Product Change Notification

1. ECR #: 218529
Notification #: 654

3. Series:
• TFM - .050 X .050 MICRO STRIPS

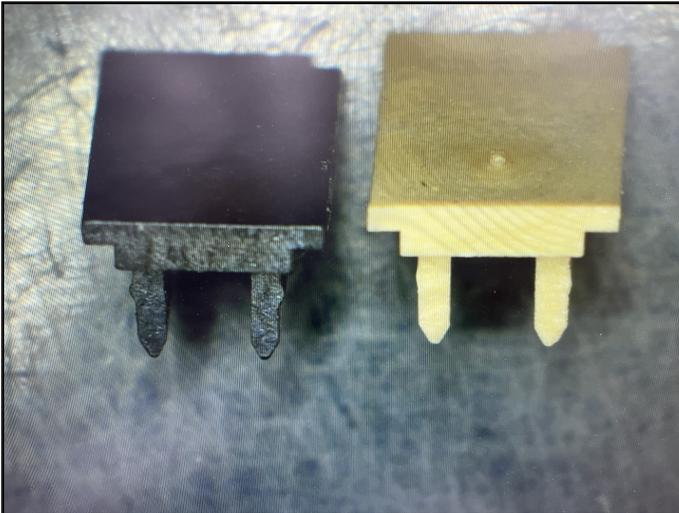
5. Description of Change:
Changing pick and place pad from black to white (aka natural).

6. Method of Identifying Change
The new product is white (aka natural) in color and the old one is black.

Black is the old pad and white (aka natural) is new pad.

7. Reason for Change:
The new pad exerts less force on the connector which helps minimize mechanical issues that a few customers experienced over the life of the TFM product.

8. Impact of Change on Form, Fit, or Function:
• Form - Color change from black to white (aka natural).
